ISSUES & REVISIONS		DATE:
△	FOR PERMIT	AUGUST 9, 2023
△	FOR CONSTRUCTION	MARCH 21, 2024
△	OWNER APPROVED PLANS	FEBRUARY 5, 2025
△	CONSTRUCTION BULLETIN #1	FEBRUARY 20, 2025
△	OWNER APPROVED PLANS	FEBRUARY 28, 2025
△		
△		
△		
△		
△

**LOPA COMPOUND
DEVELOPMENT**

HOUSE 6

**ARCHITECTURAL FLOOR
PLANS**

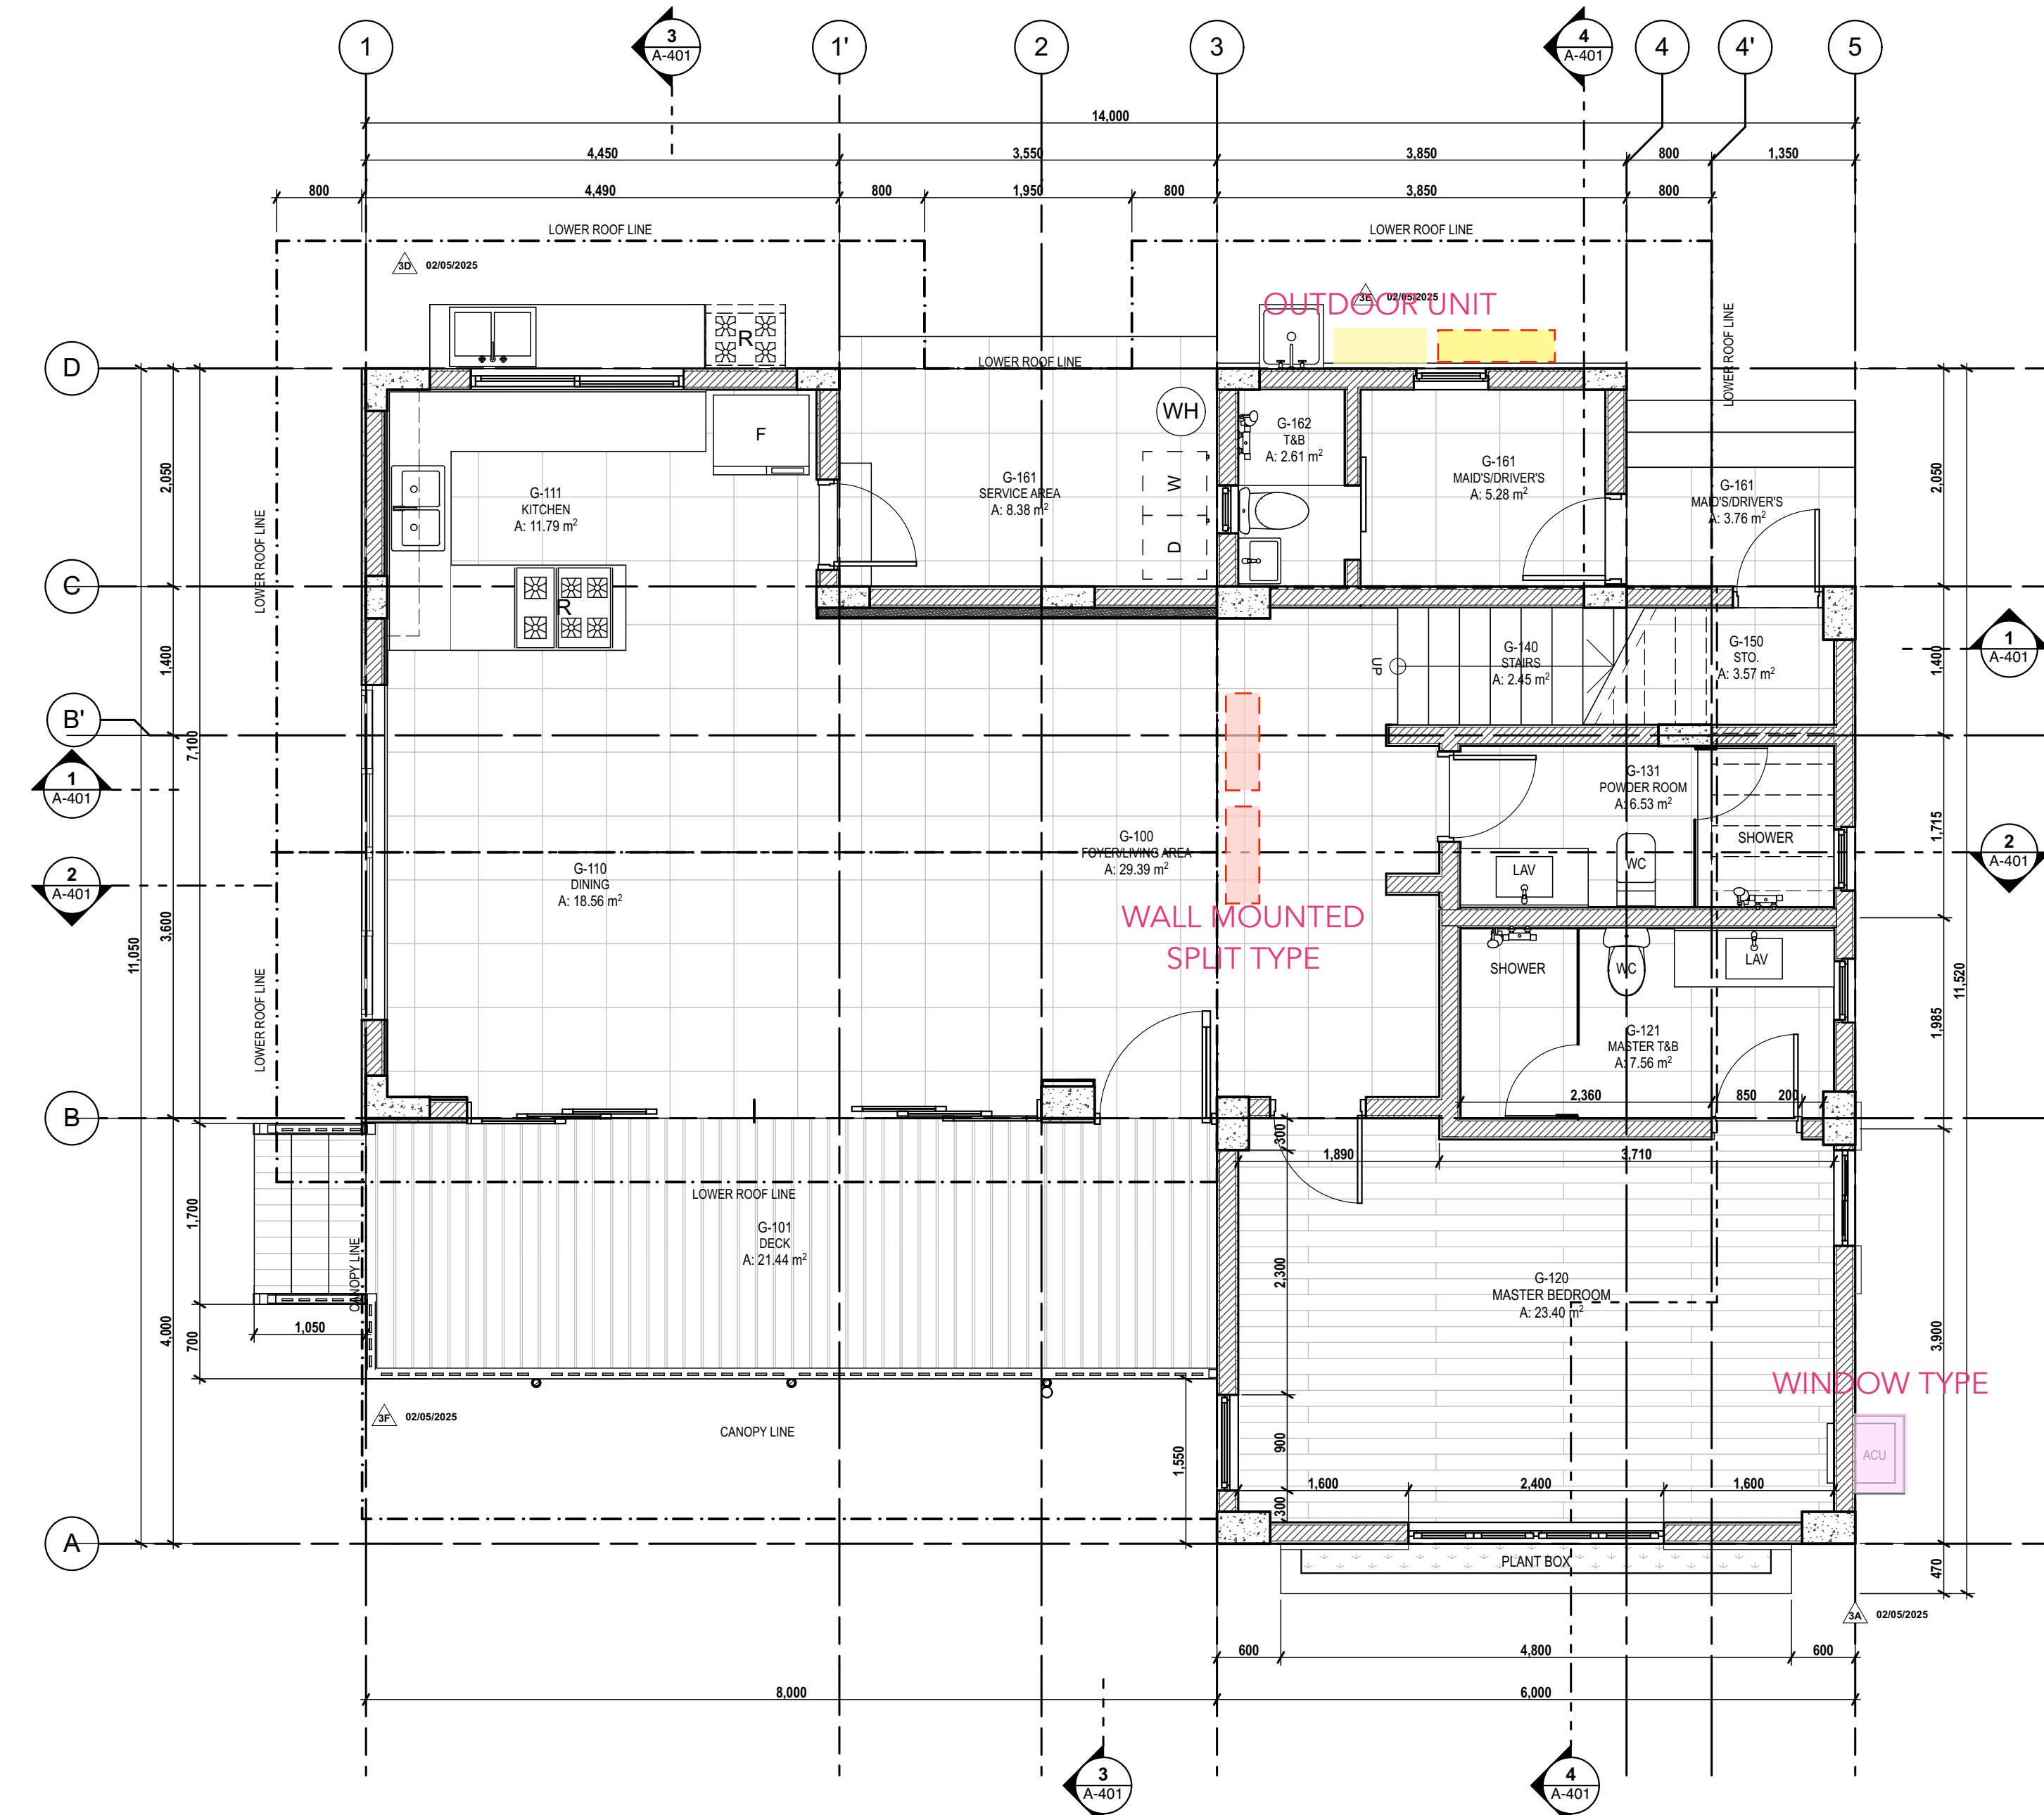
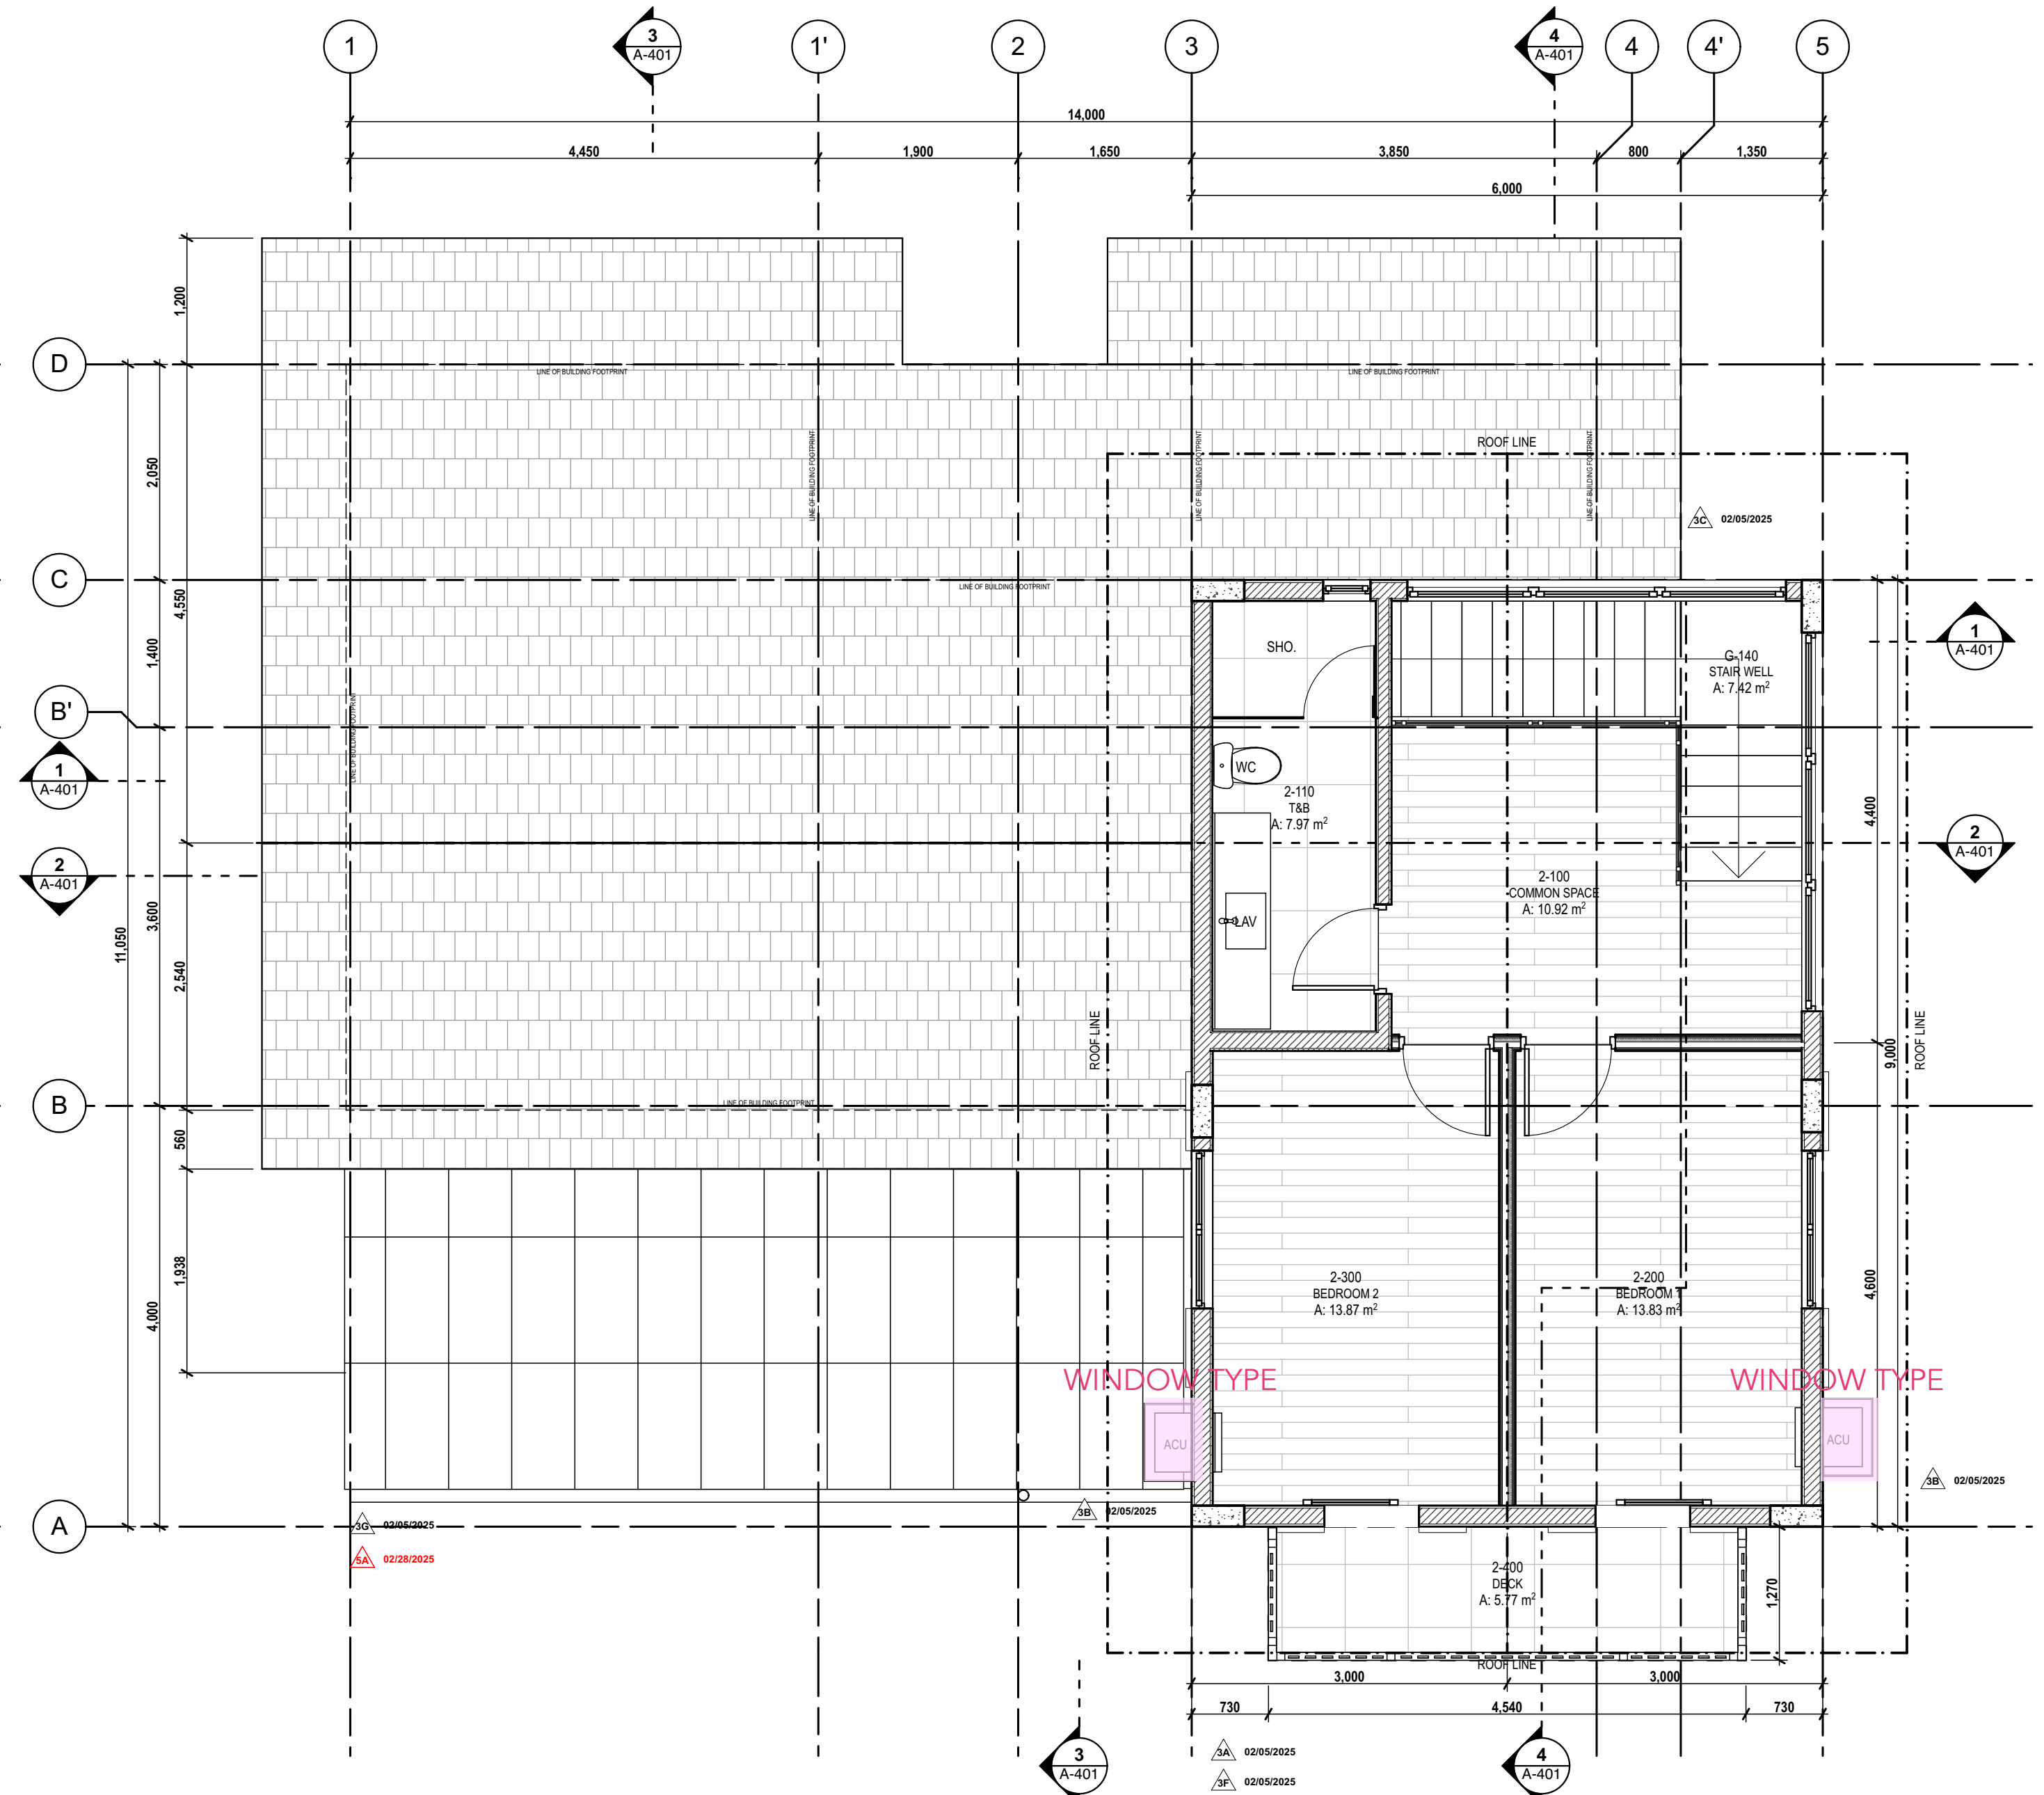
REVISION NOTES	
03/21/2024	OVERALL FLIPPING OF PLANS
02/05/2025	3A- PLACING PLANT BOX AT 1/F; THEN PLACING BALCONY AT 2/F
	3B- DECREASE WINDOW TO 1, BUT INCREASE IN SIZE; RELAYOUT THE AC
	3C- ADDITION OF LED STRIP STEP LIGHT AT THE MAIN STAIR WOSING
	3D- RELAYOUT OF INDOOR KITCHEN AND DIRTY KITCHEN
	3E- PROVISION OF SLOPSINK
	3F- REPLACING THE METAL RAILING WITH SWISS TYPE
	3G- PROVISION OF GUTTER AT GLASS TRELLIS
02/28/2025	5A- EXTENSION OF GLASS CANOPY
